Technical product information

Topic	Lower rearward levers ROW
Market area	Hongkong-Macau (5HK),Russische Föderation (5RU),Australia E04 Bentley rest Asia and Australia (6E04),China 796 VW Import Comp. Ltd (Vico), Beijing (6796),Germany E02 Bentley rest Europe (6E02),Japan E03 Bentley Japan (6E03),Russian Federation 935 Volkswagen Group RUS (6935),United Kingdom E01 Bentley UK (6E01),United States E05 Bentley USA and rest America (6E05)
Brand	Bentley
Transaction No.	2043080/1
Level	EH
Status	Approval
Release date

New specification front rearward lower levers are available

Figure 1

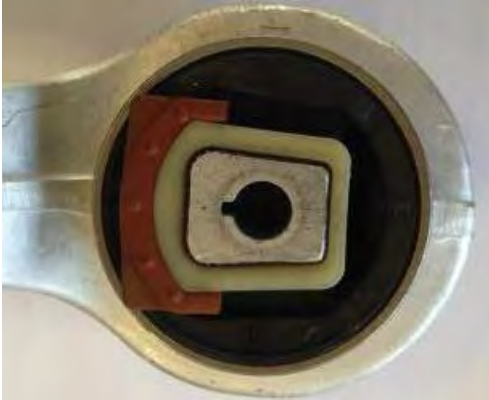
The differences are as shown in Figures 1 and 2

Figure 1, shows a lower lever with the original type bush fitted

Figure 2, shows a lower lever with the latest specification bush fitted

Figure 3

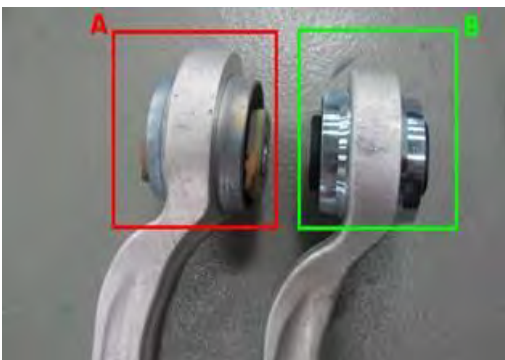
- Figure 3, shows the difference from the opposing side
- Point A is the original part (non tapered)
- Point B is the new specification (with tapered ends)
